PCN-20231204 TE0835-02 CPLD Change

Company	Trenz Electronic GmbH
PCN Number	PCN-20231204
Title	TE0835-02 CPLD Change
Subject	BOM Change
Issue Date	2023-12-07

Affected Product
TE0835-02-TXI21

#1 Changed CPLD LCMXO2-640HC-4SG48C (U31) to LCMXO2-640HC-4SG48I.

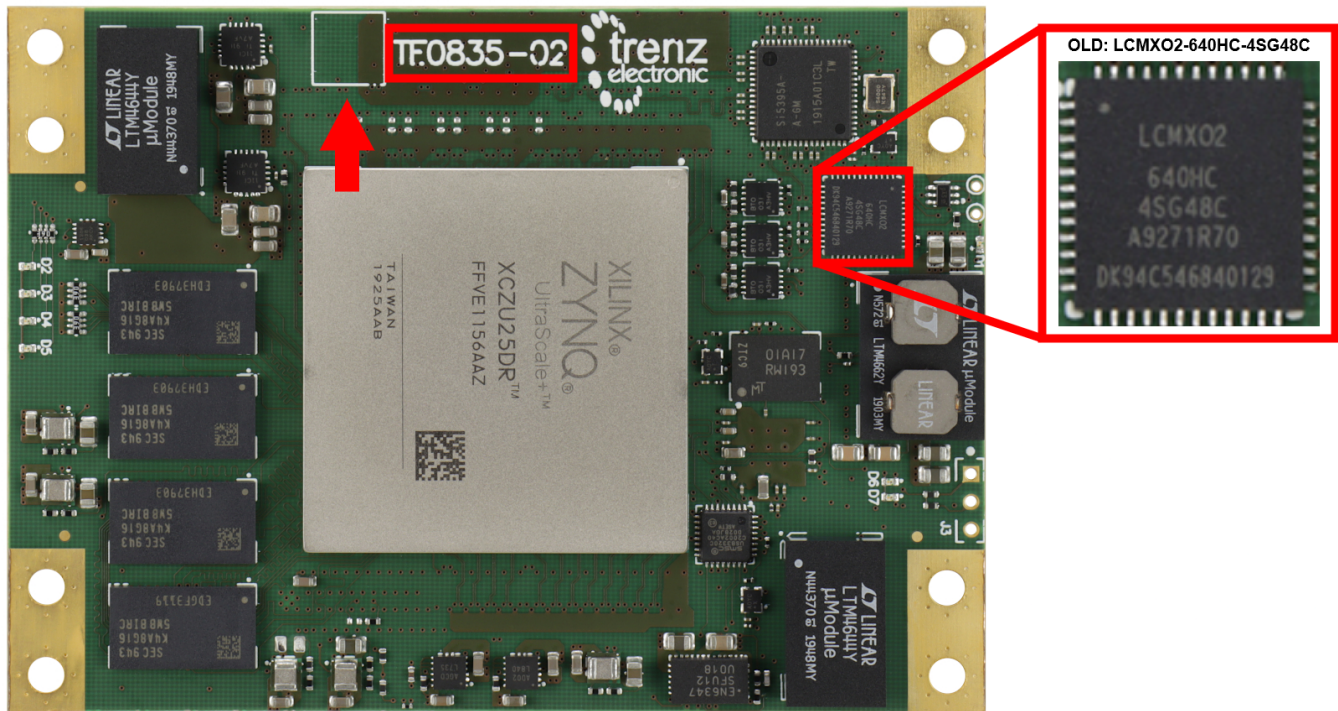
Reason: Temperature range improvement.

Impact: Increased CPLD temperature range from commercial to industrial.
